1992-02-23-0A-FEA-Moanalua Earth Movement Area
Drainage & Wall Improvements

NOTICE OF NEGATIVE DECLARATION

CONSTRUCTION OF DRAINAGE AND WALL IMPROVEMENTS

WITHIN THE MOANALUA EARTH MOVEMENT AREA

VERTICAL DRAIN WELL

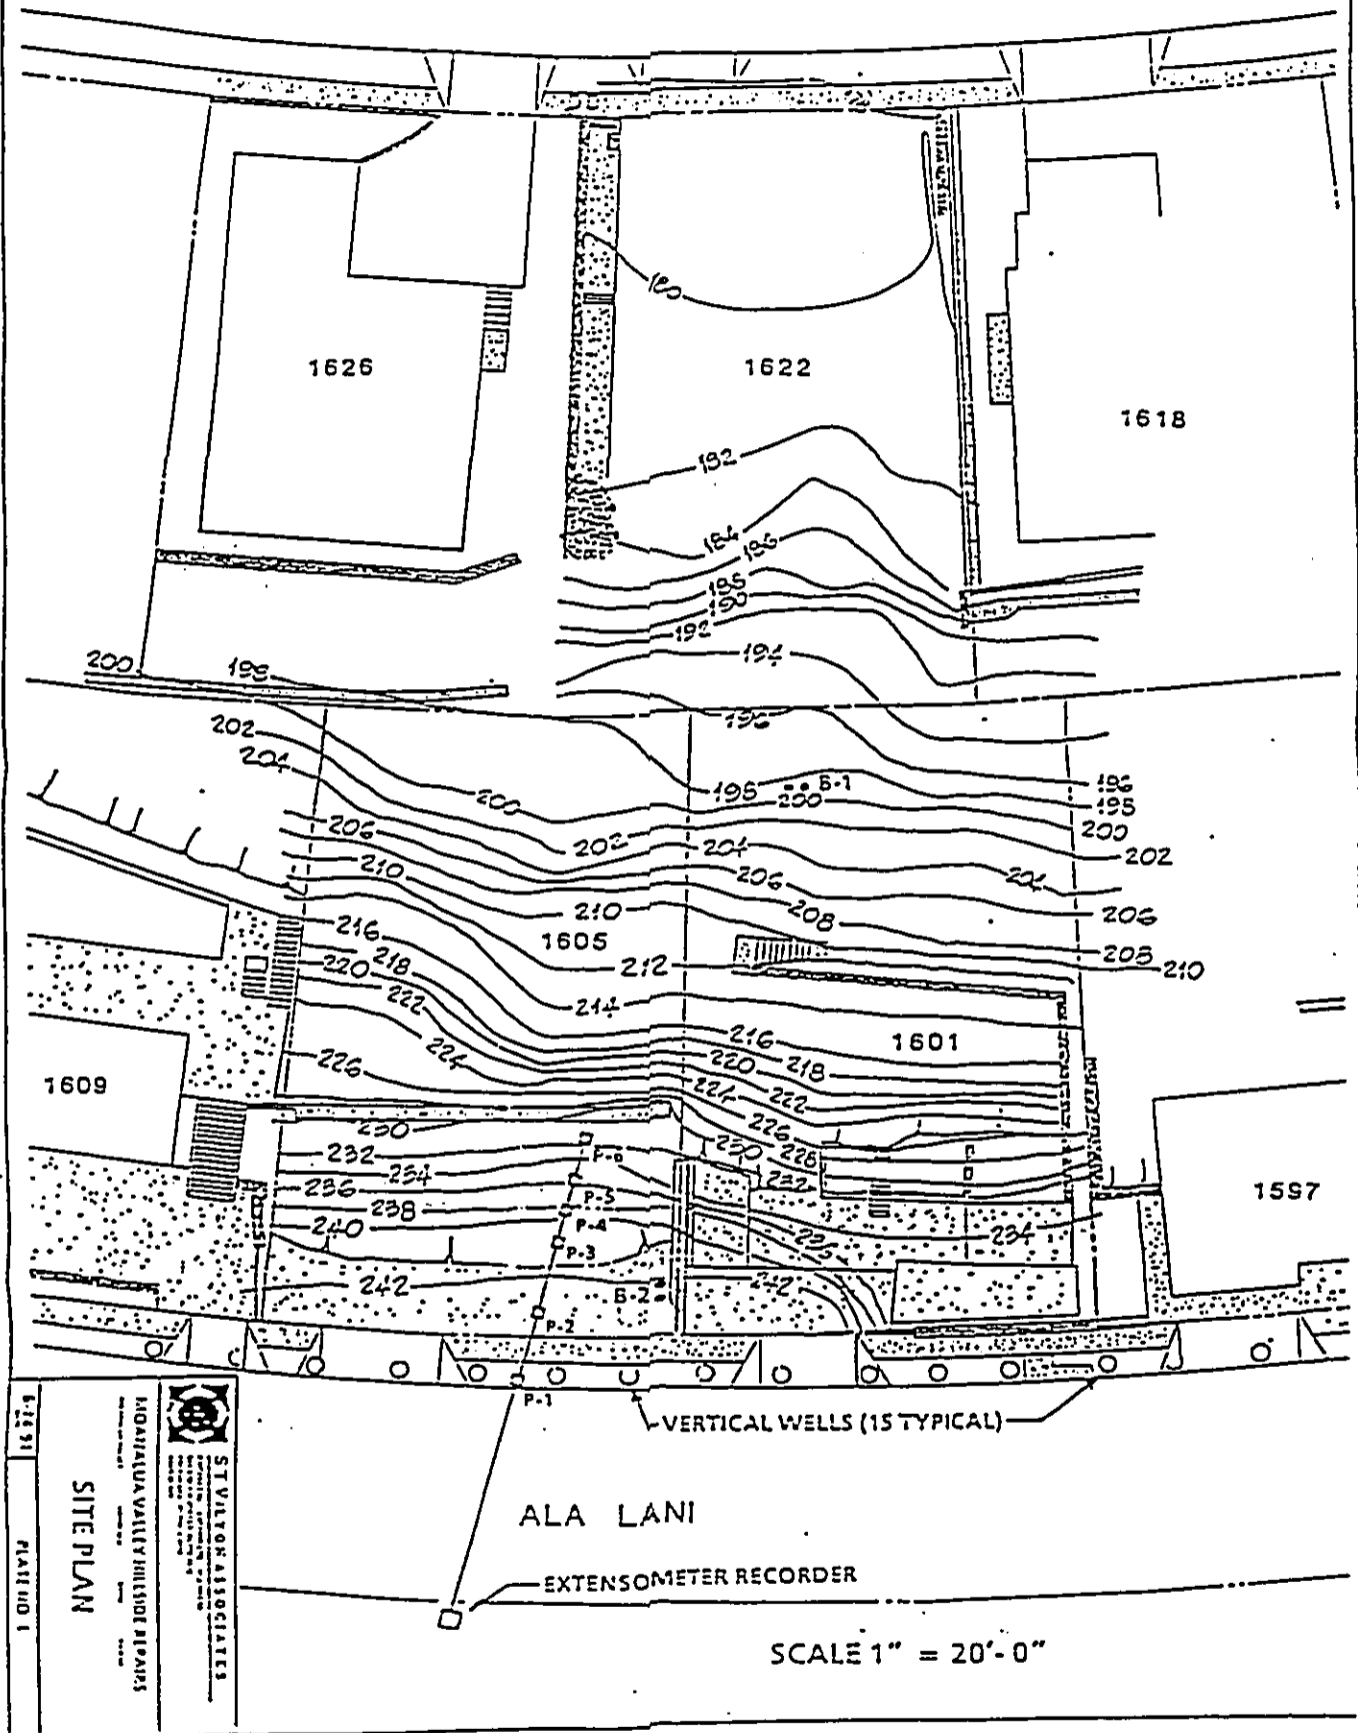
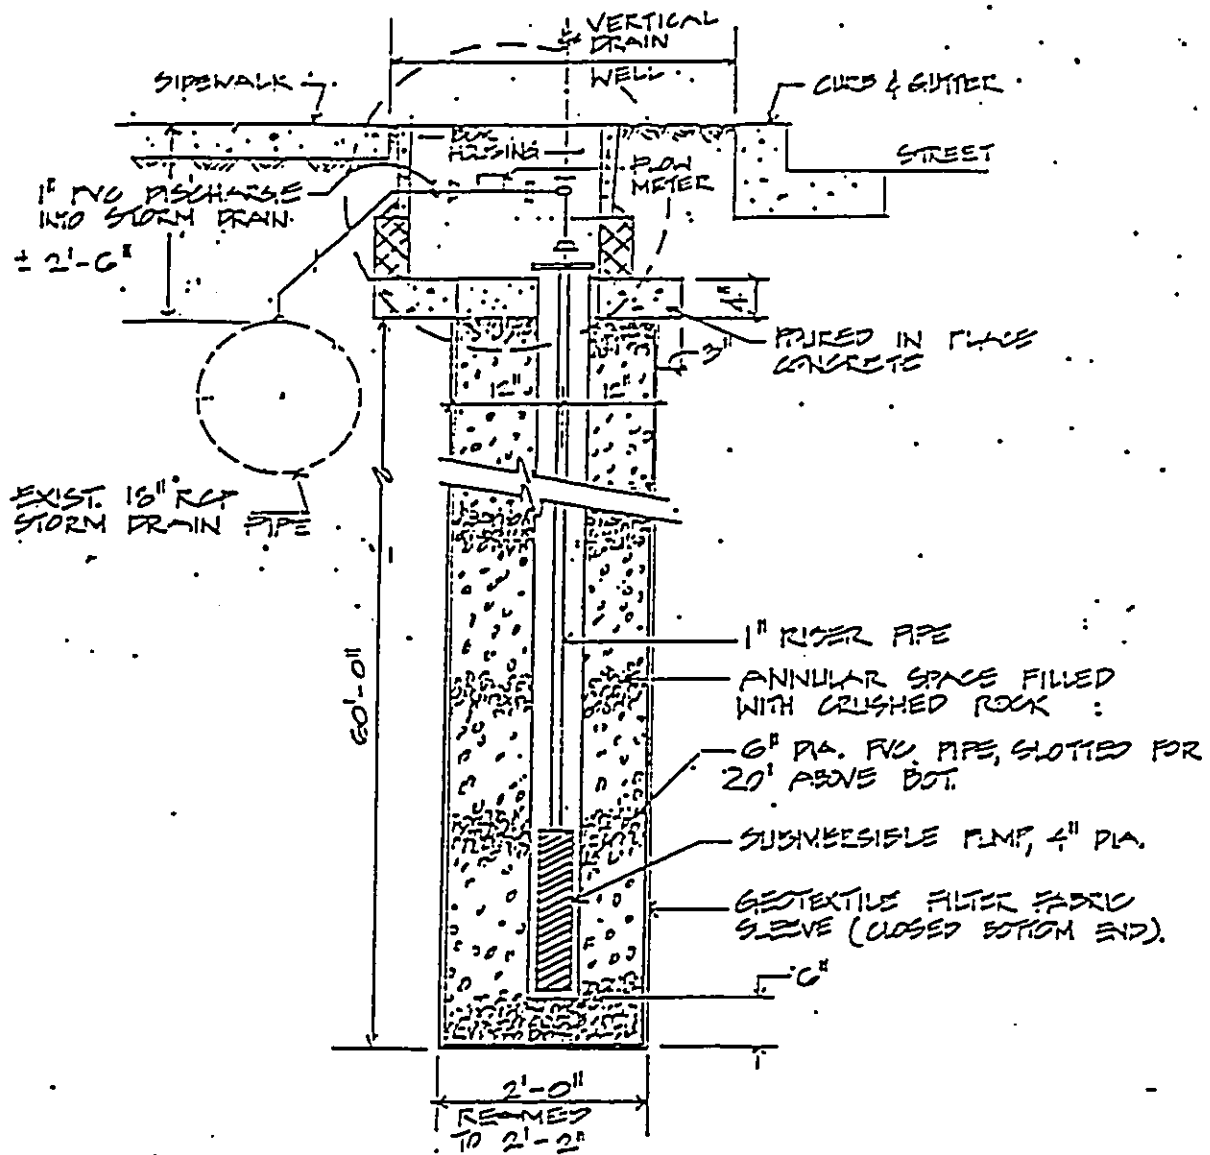
- a. Based on the submitted detail of the typical VD, we question the viability of this design to hold water in order for the submersible pump to pump the infiltrate to the surface.
- b. We question whether or not other subsurface drainage alternatives have been explored to mitigate uphill infiltrate from entering the landslide area. It seems that the use of fifteen (as shown on the plan) VD with submersible pumps and associated equipment is highly energy and maintenance intensive over a time period which has not been specified and at an operational cost which has not been projected.

- 3a. *Based on the submittal detail of the typical vertical drain, we question the viability of this design to hold water in order for the submersible pump to pump the infiltrate to the surface.*

The vertical drains are to be installed in colluvium for most of the depths involved with perhaps several penetrating into the underlying bedrock basalt. The colluvium is composed of pebbles, cobbles, and boulders in a silty clay

matrix. Some strata are more permeable and act as aquifers but the crushed rock in the vertical drain is more permeable by several orders of magnitude and will collect subsurface ground water which is expected to be deflected from its existing drainage path into the drain. The volume of flow is not expected to be high, but the important result will be a reorientation of the subsurface ground water seepage flow toward the drains and interception of most of the water now entering the upper portion of the landslide.

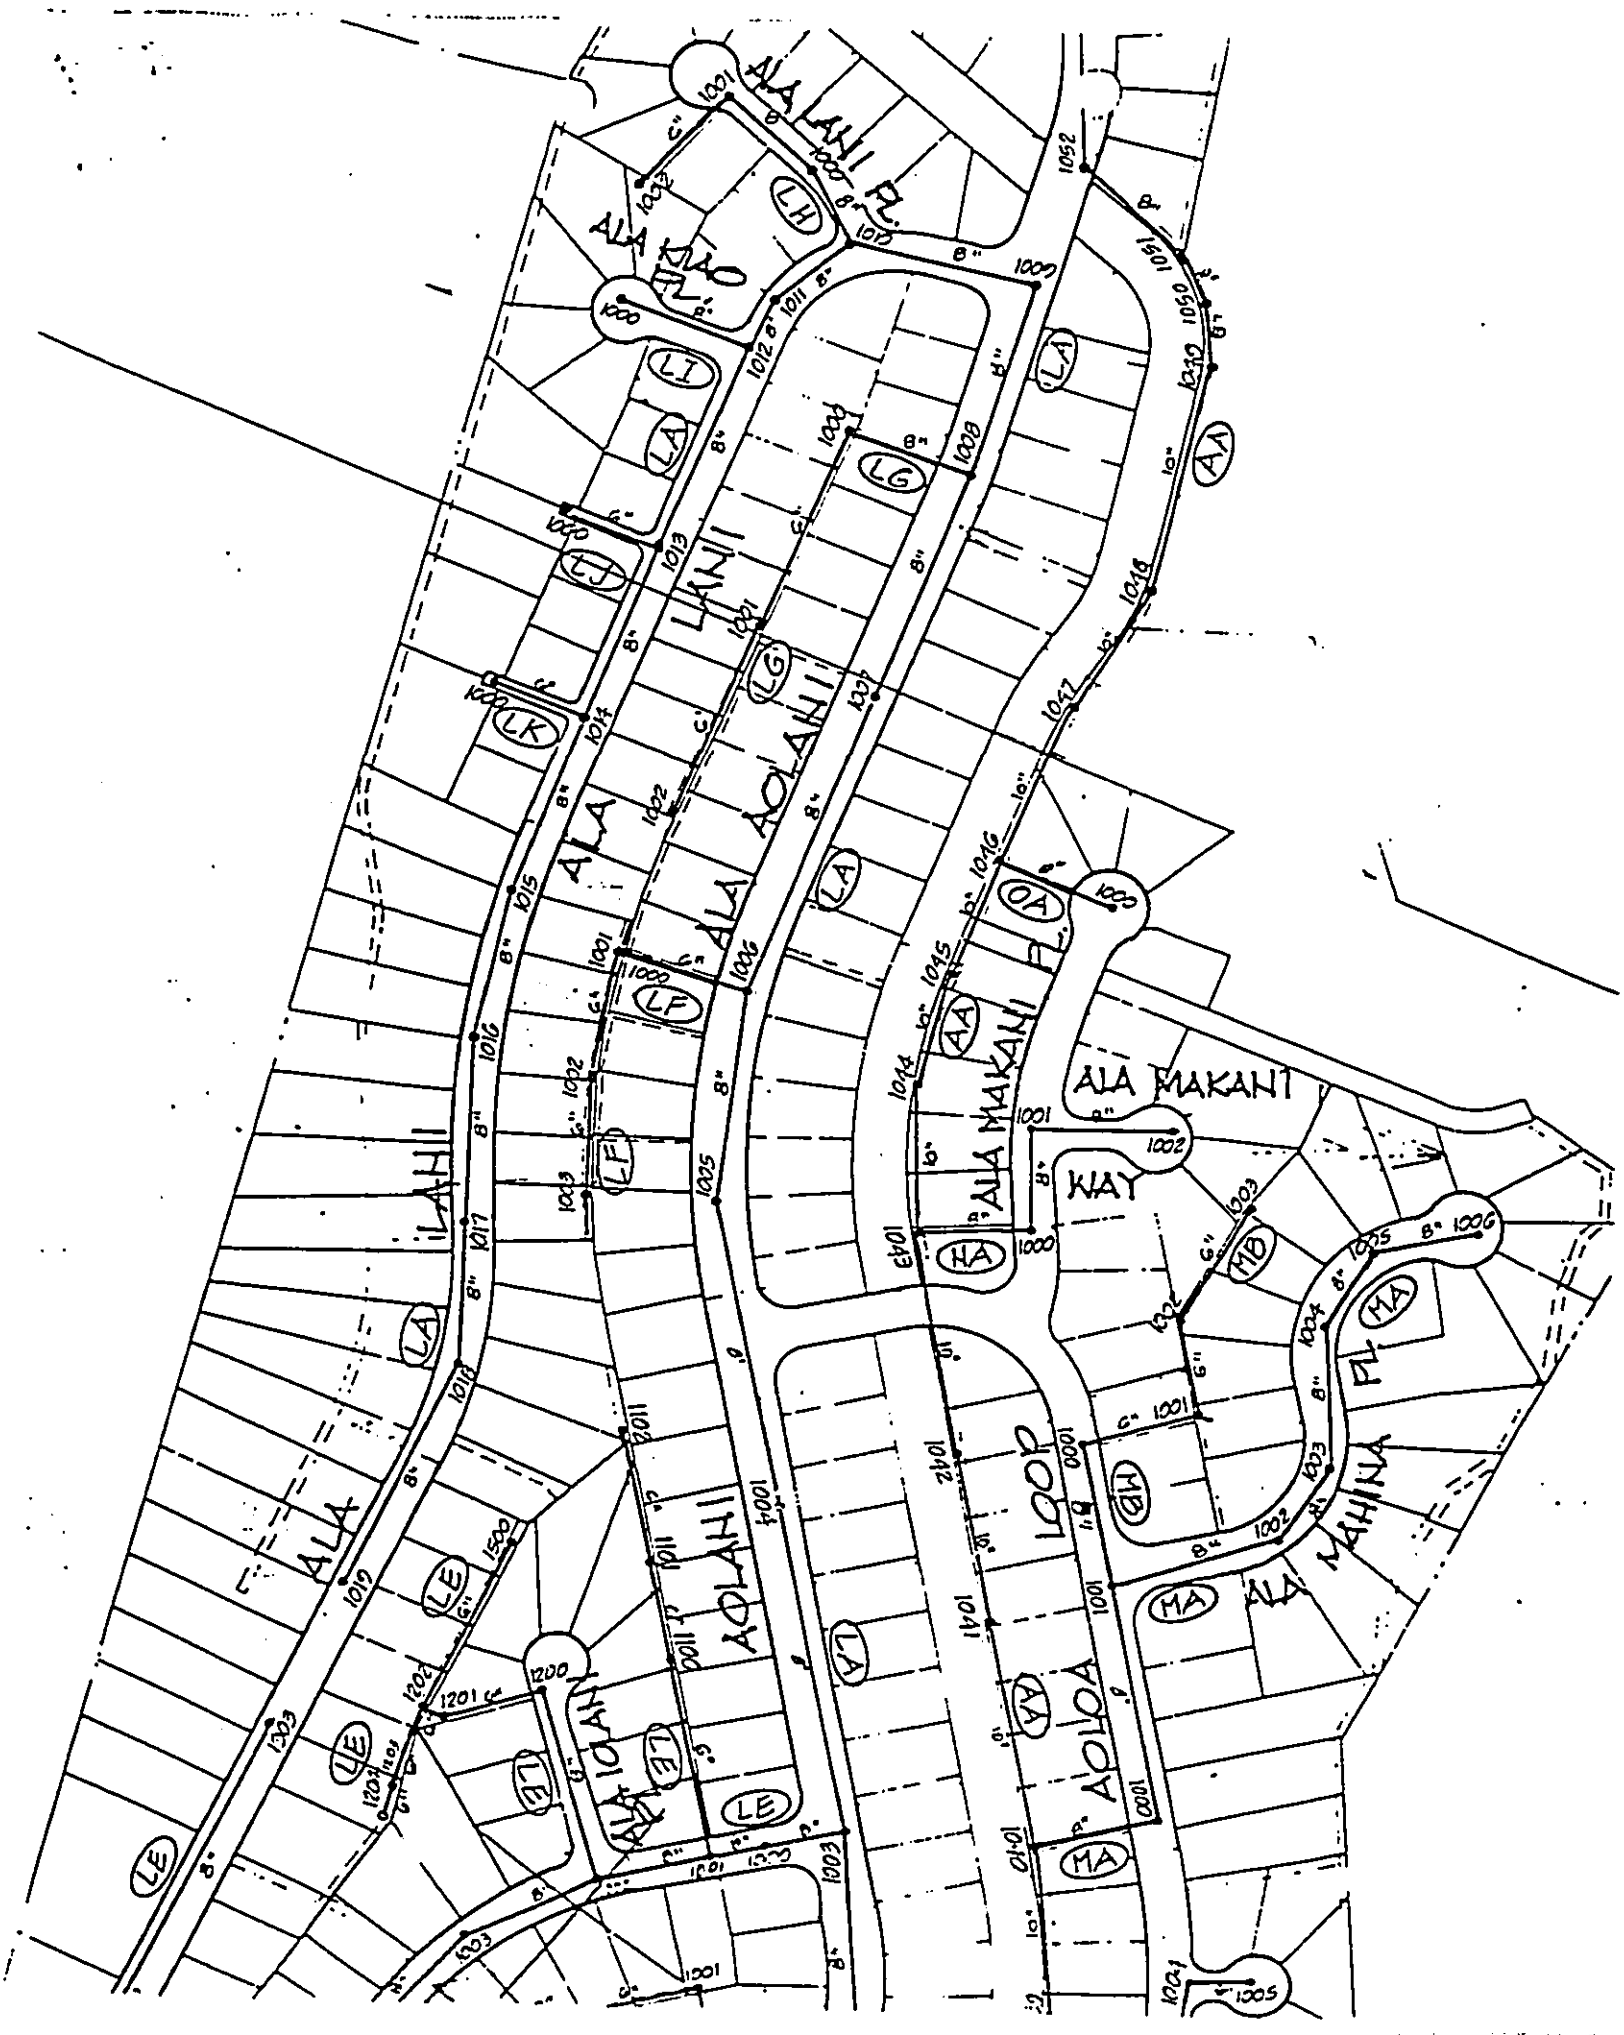
Please be informed that there are existing municipal sewer manholes and 6 and 8-inch sewer lines in the roadways and sewer easements within the subject earth movement area (see attached map). Construction plans for the drainage and wall improvements must be submitted to the Division of Wastewater Management for review and approval.
